Docket Item #3 BAR #2018-00422

November 7, 2018

ISSUE:	Request for a Certificate of Appropriateness for Alterations
APPLICANT:	Tom Dabney and Laura Machanic
LOCATION:	414 Duke Street
ZONE:	RM / Residential

Figure 1: Front entrance without railing ca. 1946-1951 (Alexandria Library Special Collections)

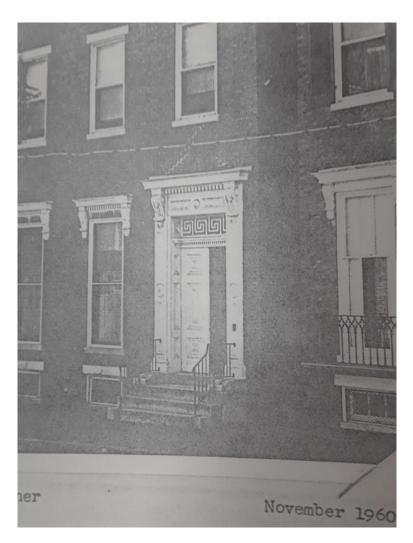
Staff was able to locate two mid-20th century photographs of the subject property, one shows no handrail the other a traditional iron picket handrail (Figure 1 & Figure 2). At some point between 1960 and today the existing, somewhat commercial looking brass tube handrail rail was added, though staff was unable to locate any approvals.

As illustrated by Figure 1, houses built prior to the mid-20<sup>th</sup> century usually did not have handrails on the stoop, though many property owners today find them to be essential to safe access to their building. The BAR's administrative approval policy only allows staff to approve simple handrails, without the balusters (or pickets) below unless they are required as a guardrail by the building code for fall protection because of the height of the stoop. The reason is that the multitude of decorative balusters can become visually distracting when walking down narrow Old Town sidewalk and are not architecturally appropriate to the period of the building or the design of the entrance. However, in this case, staff supports the design of the proposed handrail with balusters, finding the design to be high quality and architecturally appropriate at this specific Greek Revival style building, noting that the elaborate entrance design is bold enough to remain visually prominent and the railing's detailing recalls the Greek key element in the transom above the entrance door. Staff only recommends that the railing be installed in the existing holes in the stone steps and attachment to the pilaster, to avoid further damaging the original stone stoop.

PROPOSED RENDERINGS BAR SET SCALE: -September 11, 2018

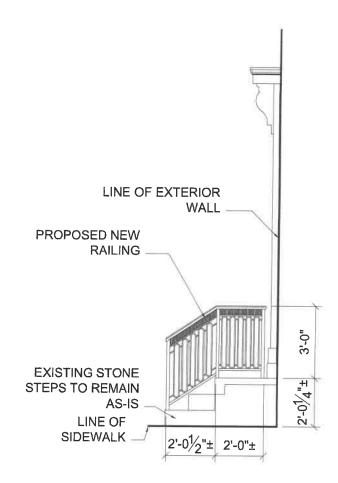
Staff has no objection to the new handrail's design, material or color. The proposed railing design features the Greek elements found at the front door transom and is consistent with the recommendations contained in the Design Guidelines, which state that:

Staff recommends approval of the application, with the condition that the new railing be mounted in the existing holes in the stone stoop.
